**From:** "Dotson, Barbara E." <bdotson@entergy.com>  
**To:** "Mahesh Chawla" <MLC@nrc.gov>  
**Date:** 09/21/2007 12:33:33 PM  
**Subject:** FW: Steam Generator Tube Inspection Discussion During Upcoming Palisades Outage

The Palisades' responses to the NRR request for Steam Generator Tube Inspection Discussion During Upcoming Palisades Outage are attached.

## **STEAM GENERATOR TUBE INSPECTION DISCUSSION DURING UPCOMING PALISADES OUTAGE**

# Primary to Secondary Leakrate

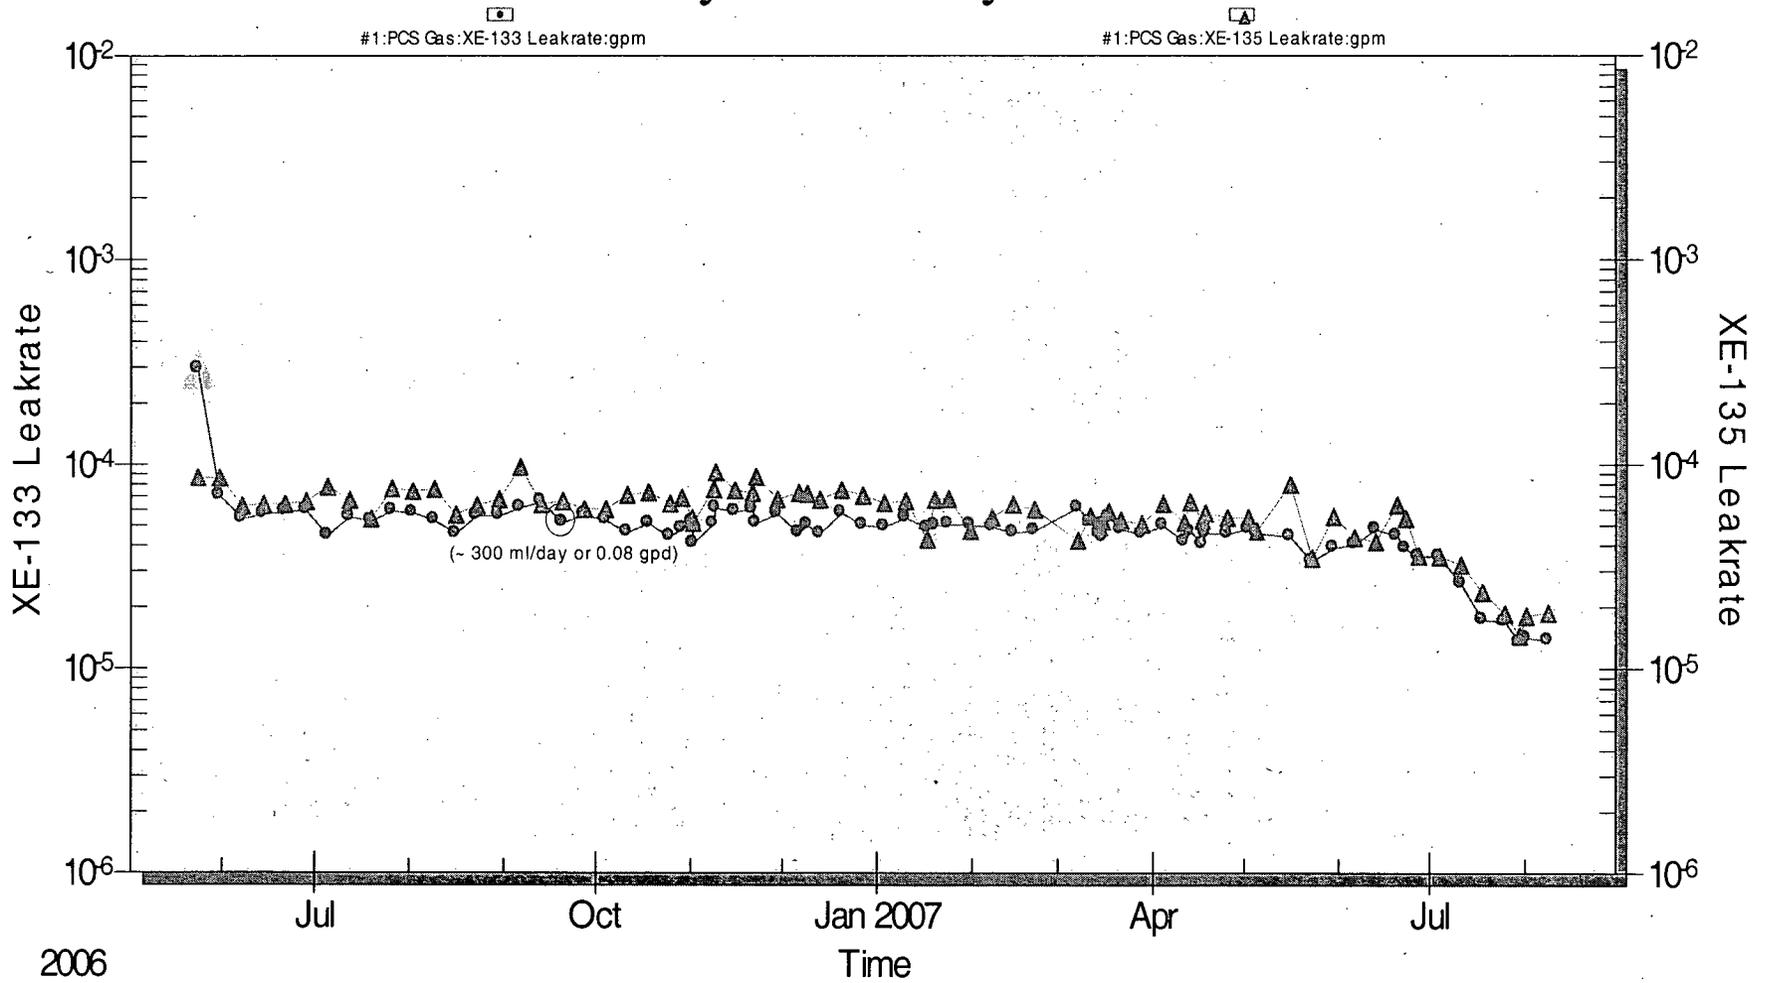
1. Discuss any trends in the amount of primary-to-secondary leakage observed during the recently completed cycle.

Refer to attached Primary to Secondary Leak Rate for Operational Cycle 19 Primary to Secondary Leak Rate graph.
